HS2 & Wendover Key Issues

Buckinghamshire Council Engagement
10th February 2021

Ground Water Levels

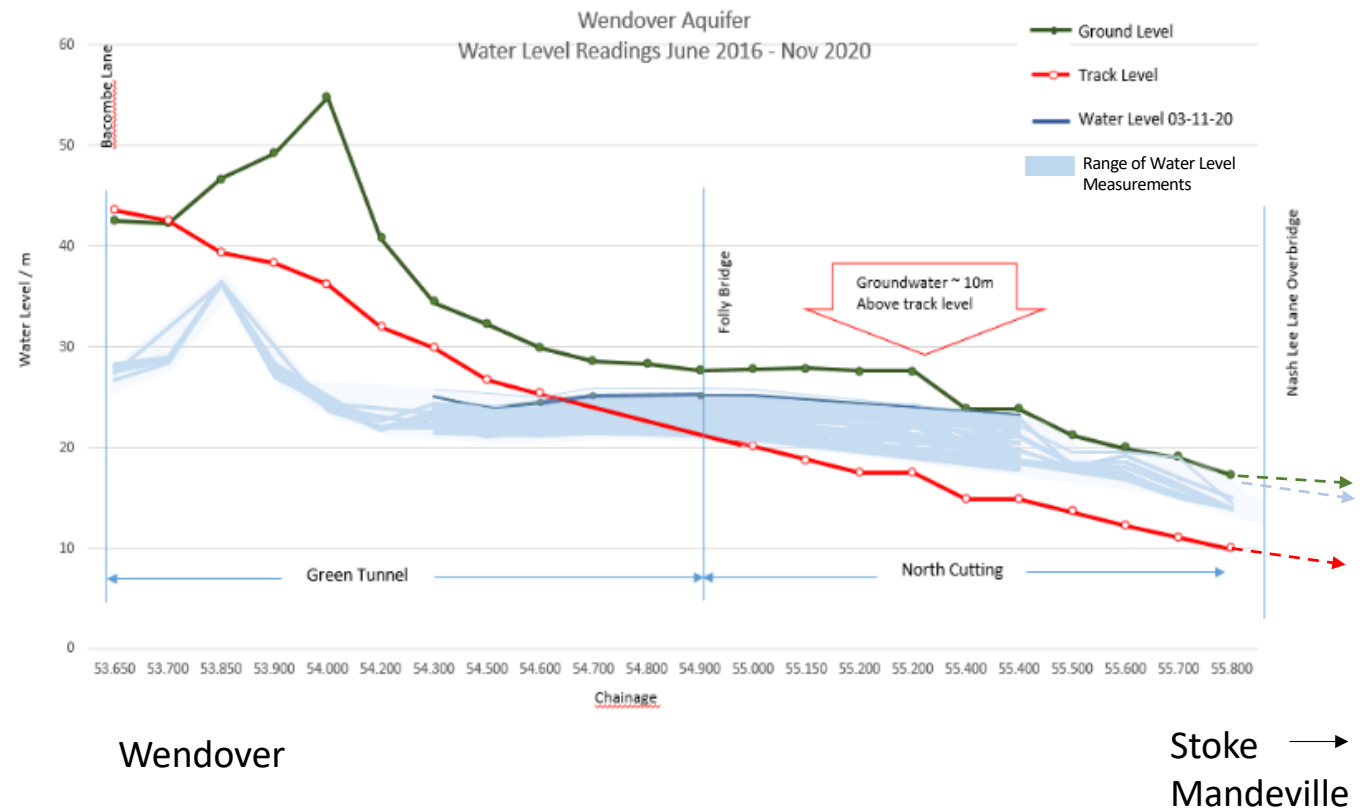
- Risk of groundwater ingress to North Cutting identified;
- HS2/EKFB to do further modelling based on pump tests;
- HS2/EKFB drainage design at Nash Lee will cover 1:100 year surface water flood event and not include diverted aquifer water;

Undertaking U&A 49 requires mitigation and recharge and U&A 50 not to increase flood risk

Our Concerns

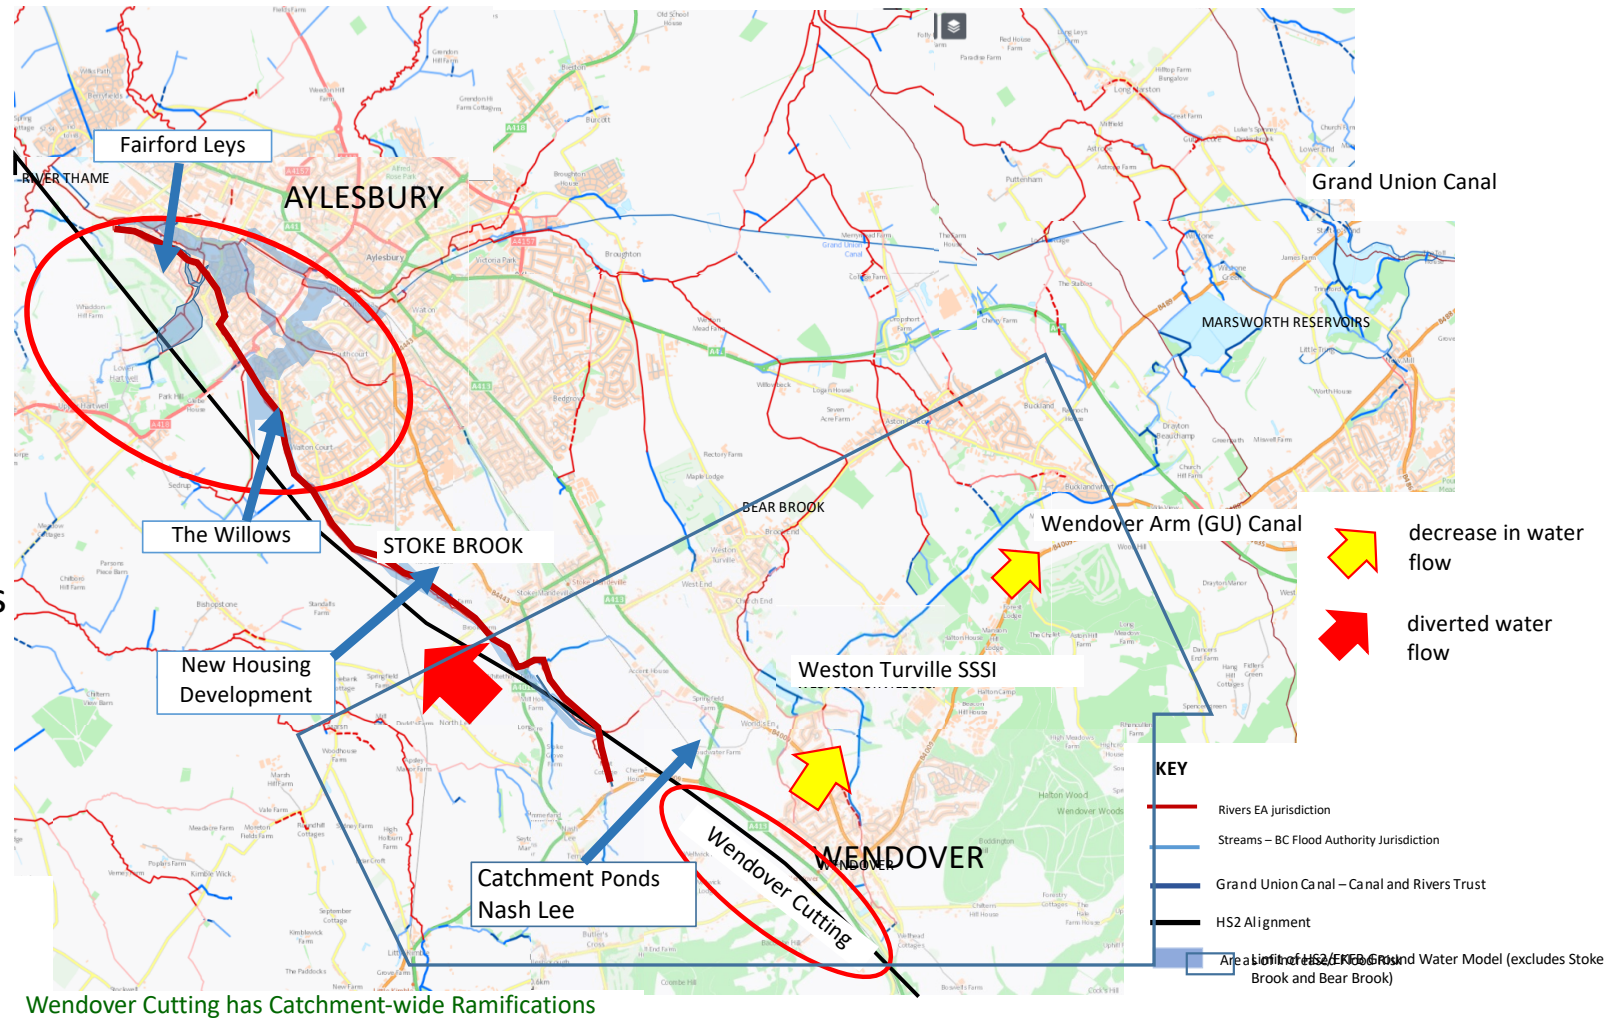
- Catchment wide problem not an isolated section problem, but HS2 still don't recognise this;
- Current EKFB ground water modelling understates reality;
- HS2 confirm design has NO mitigation built in;
- Tunnel and Cutting design potentially flawed;

Wendover North cutting Concept section for retained cutting View North

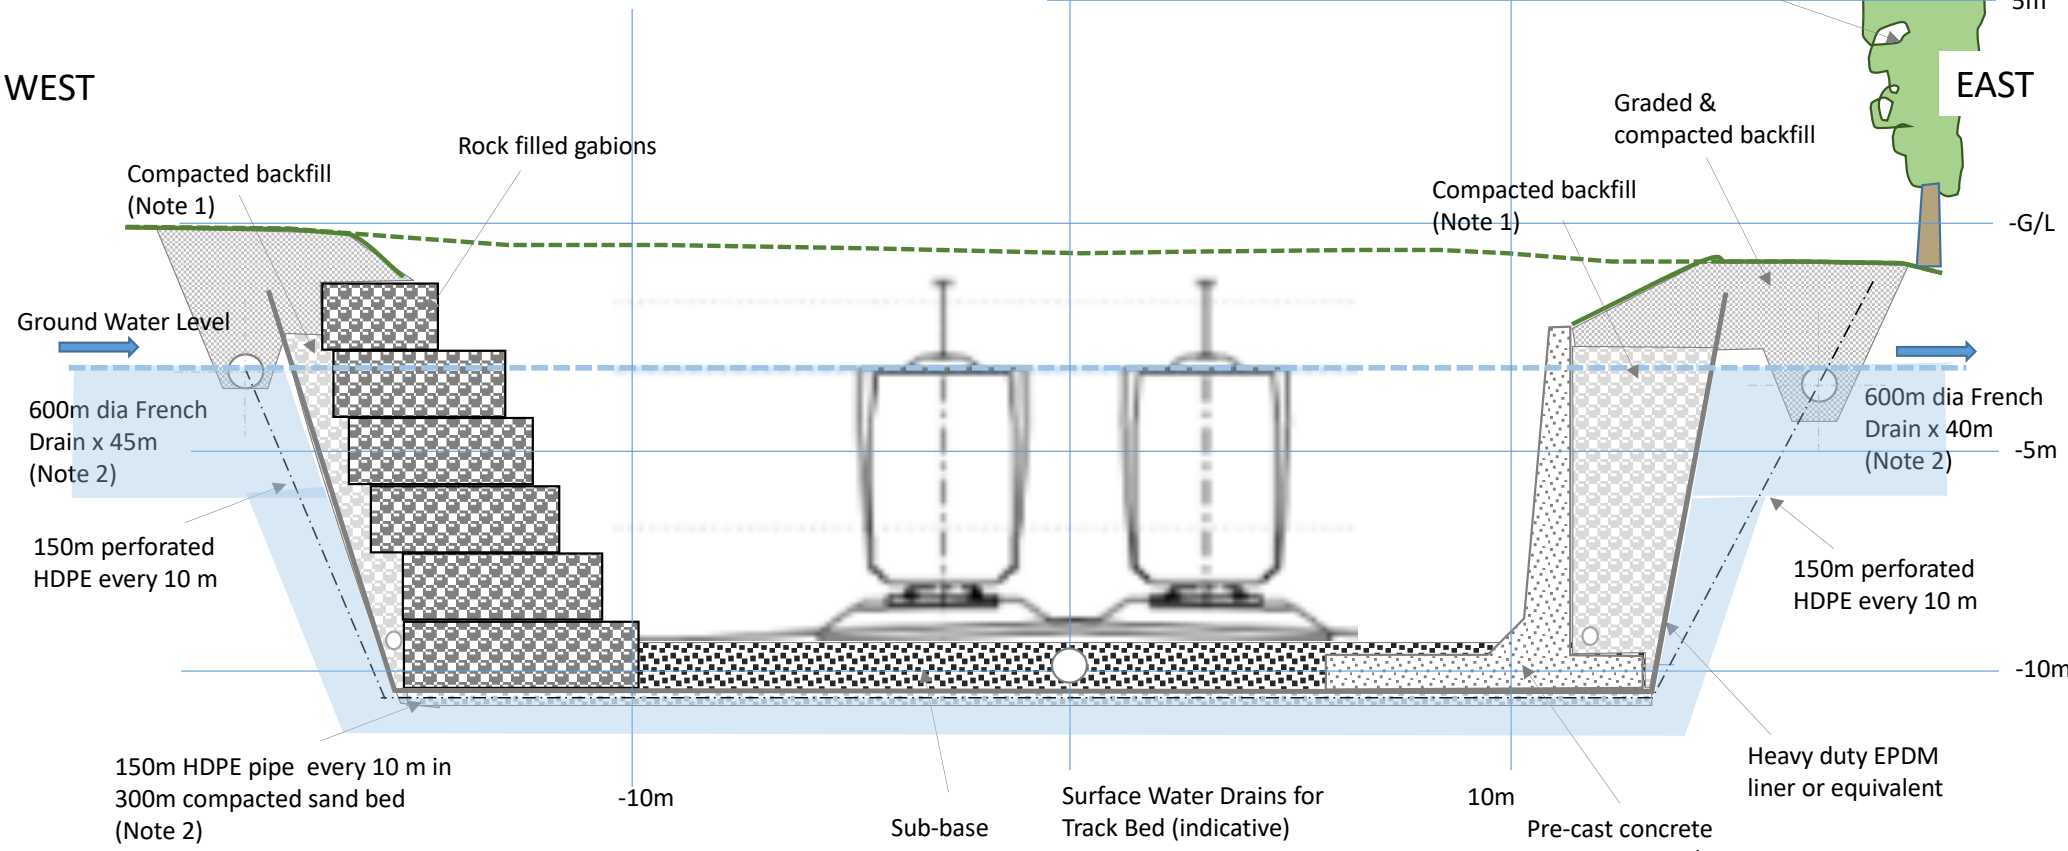
- “Retained” Wendover North Cutting
 - 7dB improvement brings ~402 houses within LOAEL
 - Minimises Aquifer disruption
 - Reduces excavation and enables off site pre-fabrication
 - Saving vs anticipated costs
- Arched barriers at Small Dean
 - 5dB improvement saves Church & Chiltern Way Academy outdoor activities, brings ~121 houses within LOAEL
 - Reuse of North Cutting savings, making overall project cost neutral

1. At each 50m intervals backfill separated by cast in situ concrete barrier or baffle made from sandbags to prevent water flow through backfill perpendicular to track
2. Each French drain section (45m long) to be inter-connected with 4 off under pass pipes to intercept and disperse aquifer water from West to East
3. Sheet piling to be avoided as this will intercept Ground water flow
